Reference: Hanford Waste Vitrification Plant
 DOE Contract DE-AC06-86RL10838
 Fluor Contract 8457

FLUOR DANIEL US DEPARTMENT OF ENERGY HANFORD WASTE VITRIFICATION PLANT DESIGN CHANGE NOTICE	DCN - 000053	REV 0	PAGE 1 OF 6
	DCN TITLE <i>ISSUE CONSTRUCTION HOLD ON INSTRUMENT AIR LINES.</i>		DATE INITIATED 7-8-93
			PACKAGE NO. A160

PROVIDE HOLD ON INSTRUMENT AIR LINES 1X-1" 410-001-G AND 1X-1" 410-003-G @ UTILITY STATIONS IN BUILDINGS BD-20 AND 21. HOLD NUMBER HWVP-FD-343. (INSTRUMENT AIR IS NOT ACCEPTABLE FOR UTILITY STATION USE)

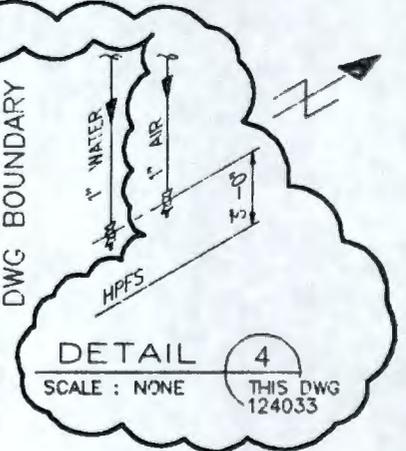
HOLD NO. HWVP-FD-343
DCN 000053

FLUOR DANIEL		U.S. DEPARTMENT OF ENERGY HANFORD WASTE VITRIFICATION PLANT		DESIGN CHANGE NOTICE	
DESCRIPTION OF CHANGE: PROVIDE HOLD ON INSTRUMENT AIR LINE (LINE NUMBER IAX-1"-410-003-G)					
PREPARED BY: R. HERBERS		DATE: 6/29/93		BASE DOC. NO. H-2-124030	
DISCIPLINE ENGINEER: <i>J.P. Ours</i>		DATE: 7-12-93		SHT/PG. 1 REV. 2	
DISCIPLINE: PIPING				CR NO.	
DCN - 000053				DISCIPLINE: PIPING	
ACAD				PAGE 3 REV. 0

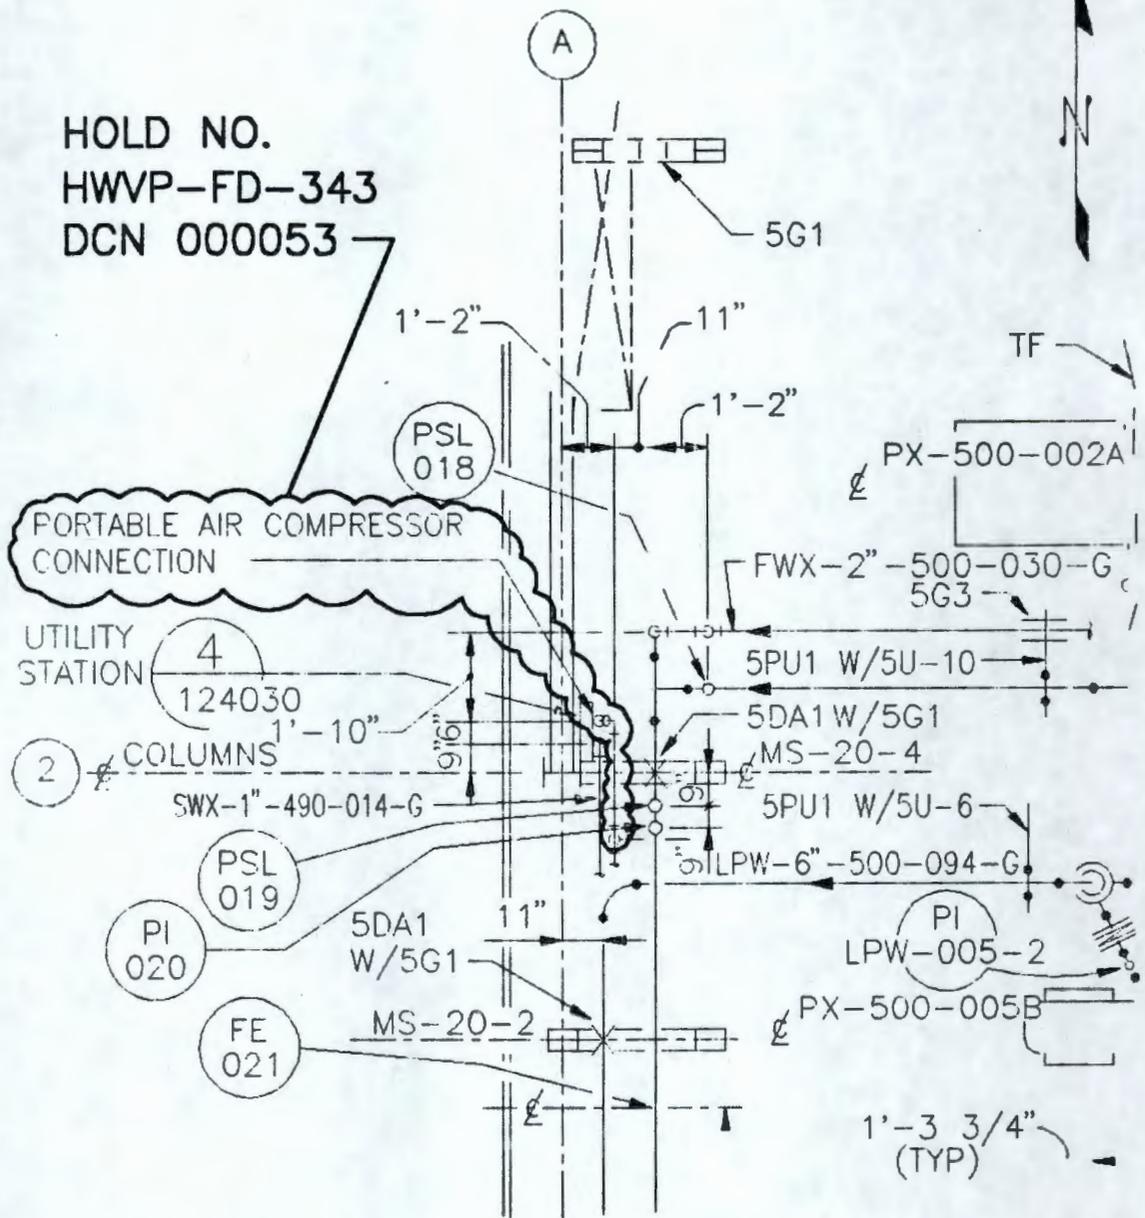
HOLD NO.
HWVP-FD-343
DCN 000053

FLUOR DANIEL		U.S. DEPARTMENT OF ENERGY HANFORD WASTE VITRIFICATION PLANT		DESIGN CHANGE NOTICE	
DESCRIPTION OF CHANGE: PROVIDE HOLD ON INSTRUMENT AIR LINE (LINE NUMBER IAX-1"-410-001-G)				BASE DOC. NO. H-2-124033 SHT/PG. 1 REV. 2 CR NO. DISCIPLINE: PIPING	
PREPARED BY: R. HERBERS		DATE: 6/29/93		PAGE 4 REV. 0	
DISCIPLINE ENGINEER: <i>J. Ouss</i>		DATE: 7-12-93		DCN - 000053

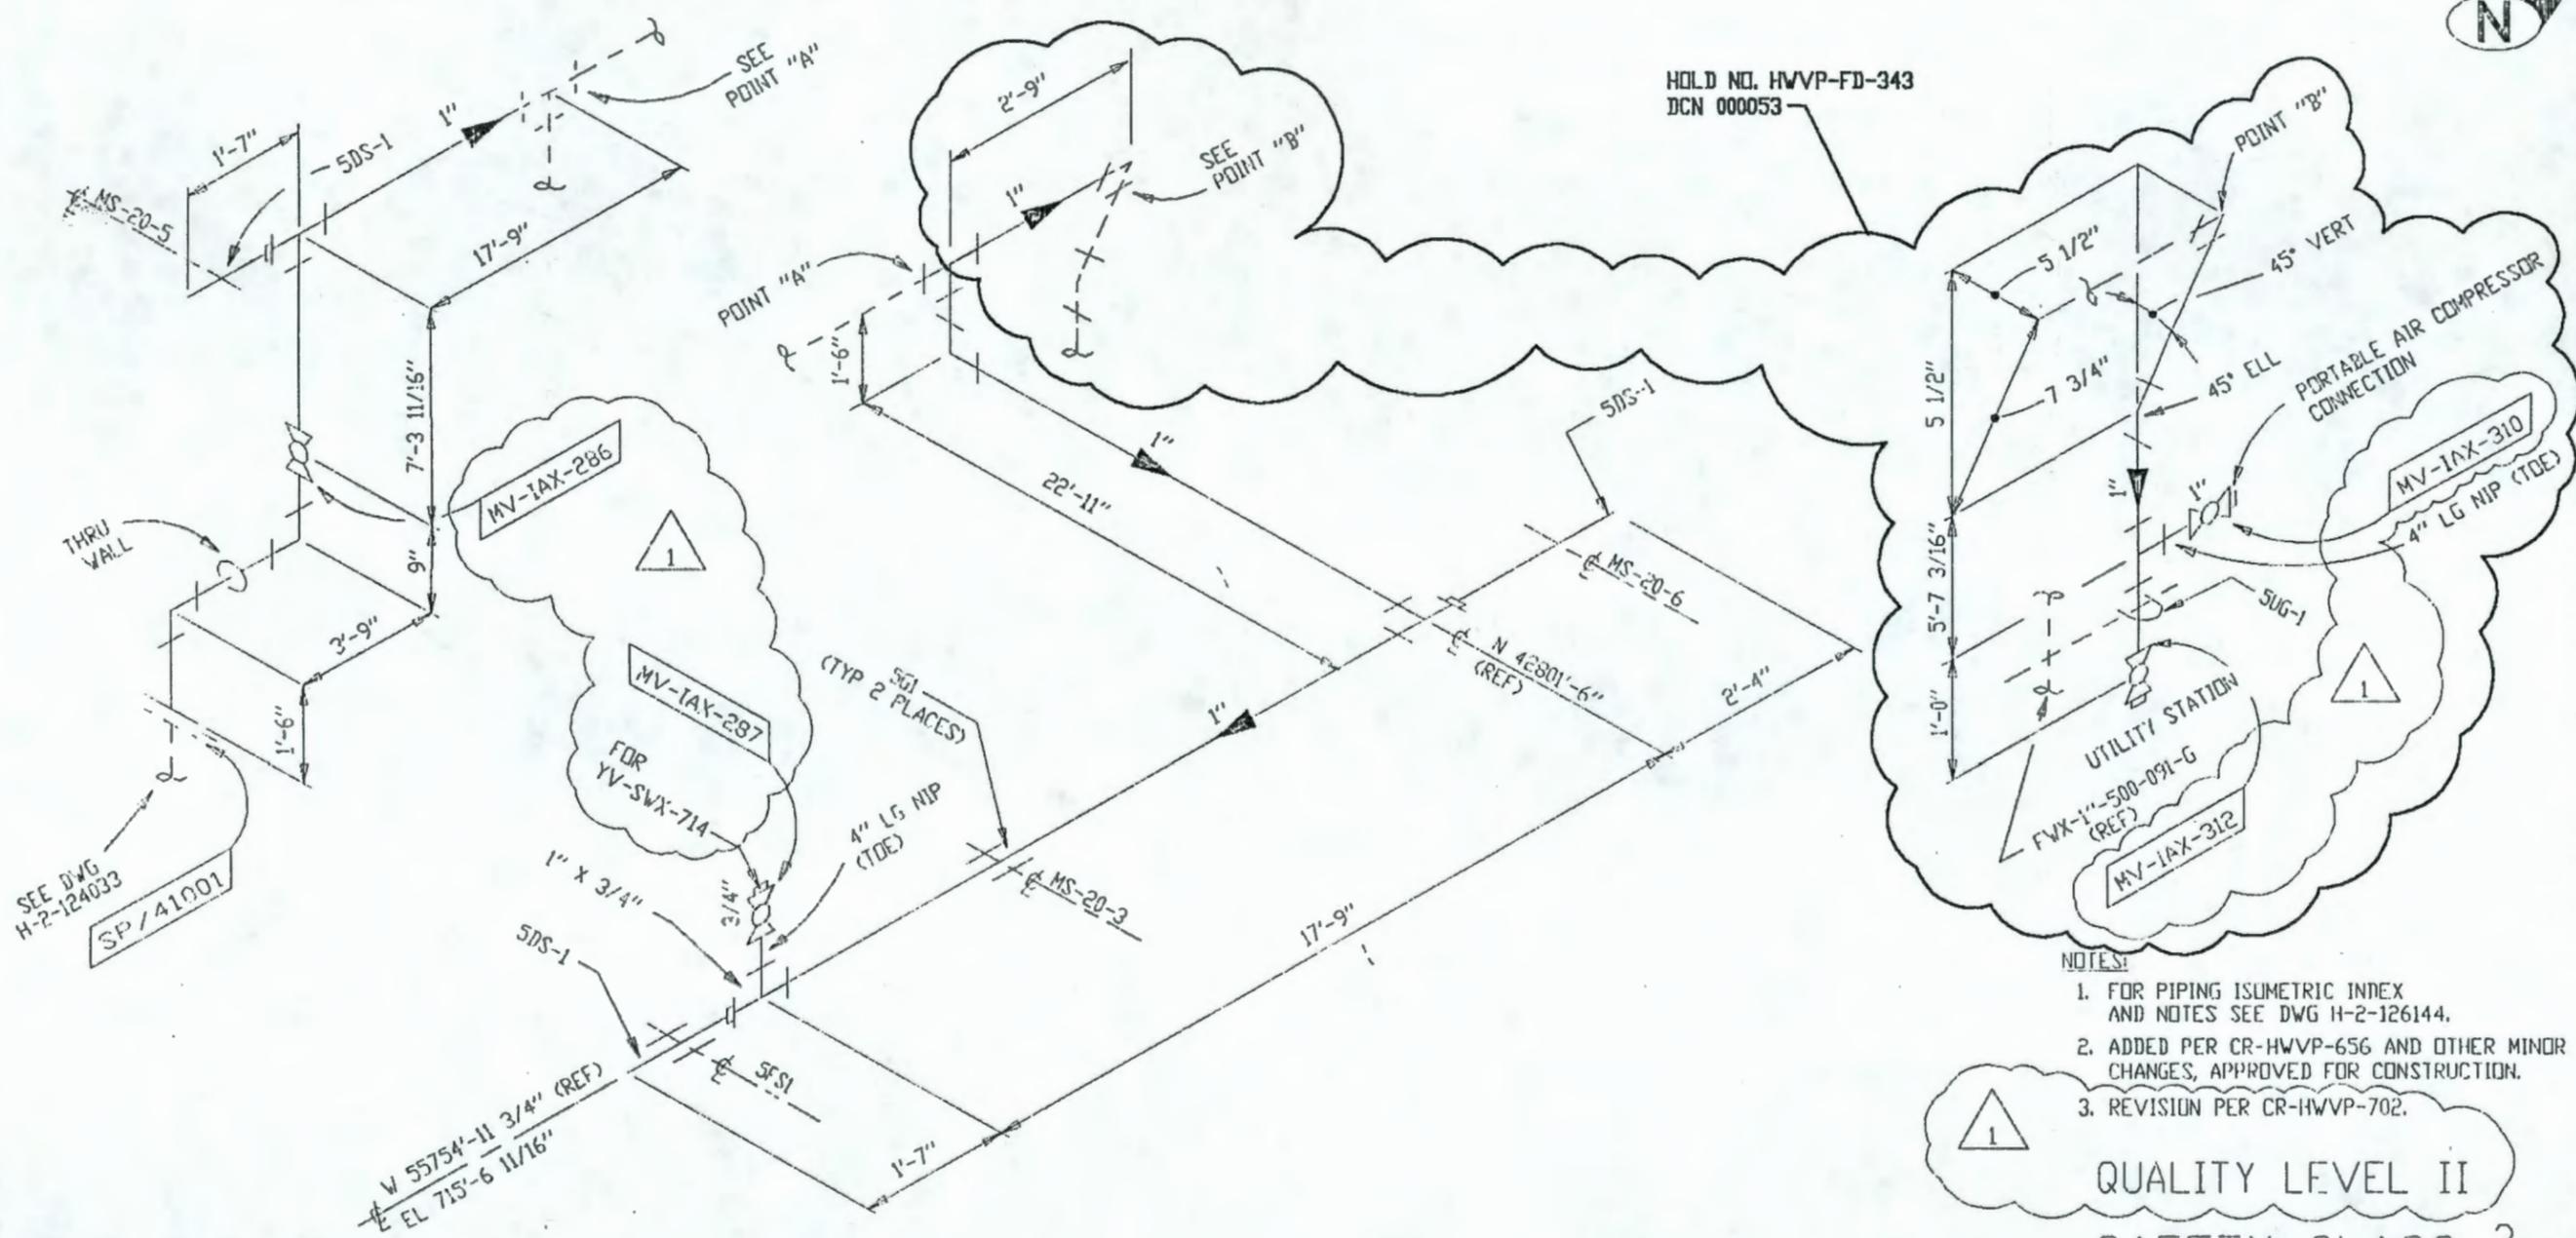
HOLD NO. HWVP-FD-343
DCN 000053

FLUOR DANIEL		U.S. DEPARTMENT OF ENERGY HANFORD WASTE VITRIFICATION PLANT		DESIGN CHANGE NOTICE	
DESCRIPTION OF CHANGE PROVIDE HOLD ON INSTRUMENT AIR LINE (LINE NUMBER IAX-1"-410-001-G)				BASE DDC. NO. H-2-126148 SHT/PG. 3 REV. 1 CR NO. DISCIPLINE: PIPING	
PREPARED BY: R.HERBERS		DATE: 7/1/93		REV. PAGE 0 6	
DISCIPLINE ENGINEER: <i>[Signature]</i>		DATE: 7-12-93		DCN - 000053
